MIL-PRF-19207/31F
w/AMENDMENT 2
14 January 2025

PERFORMANCE SPECIFICATION SHEET

FUSEHOLDERS, EXTRACTOR POST TYPE, NONINDICATING, TYPES FHN47W AND FHN47WB

FIGURE 1. Type FHN47W and type FHN47WB fuseholder.

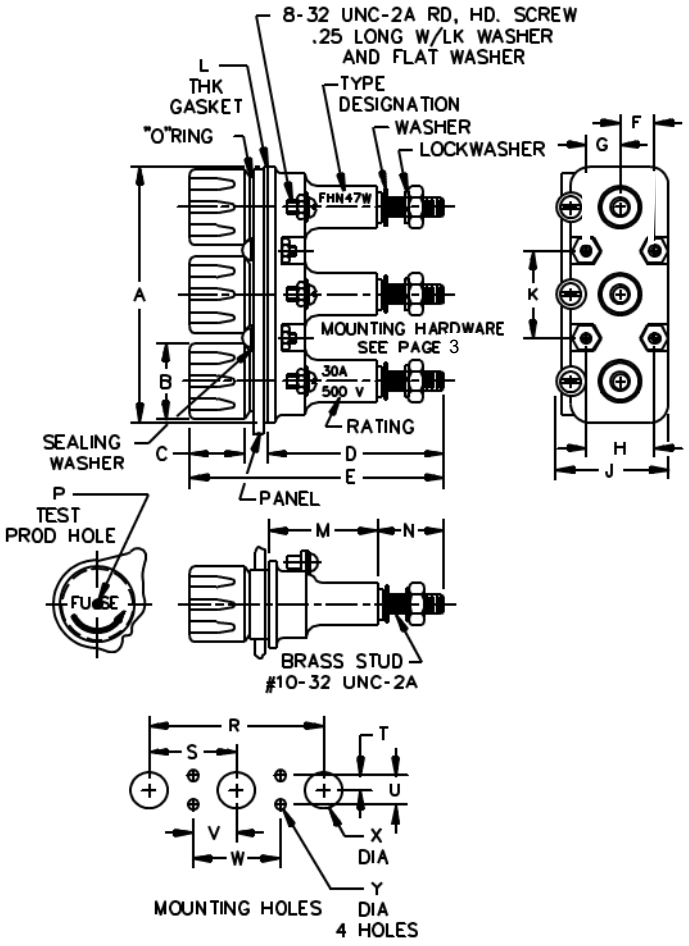
CAUTION: Users are cautioned regarding the new torque terminal requirement which is lowered from 25 inch-pounds to 15 inch-pounds. (See page 3).

Torque: Cap - 36 inch-pounds, terminal - 15 inch-pounds.
